Road Safety Audit Stage 1

Darland Farm

Proposed Access and Traffic Calming

Project Title Darland Farm, Chatham – Proposed Access and Traffic Calming

Figure 1: Restricted visibility could compromise road safety.

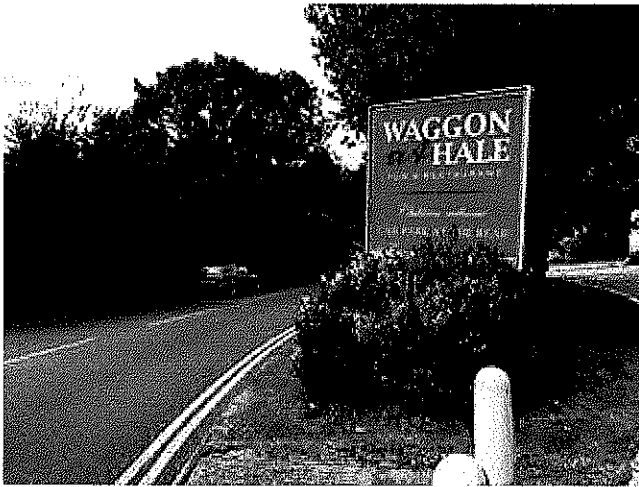
Location: Proposed pedestrian crossing on Capstone Road.

Summary: Lack of visibility may lead to pedestrian accidents.

Visibility to the northwest, at the proposed crossing on Capstone Road is restricted by signage and vegetation, see figure 1 below. Restricted visibility could lead to pedestrian accidents.

That suitable intervisibility should be provided or that the crossing should be relocated.
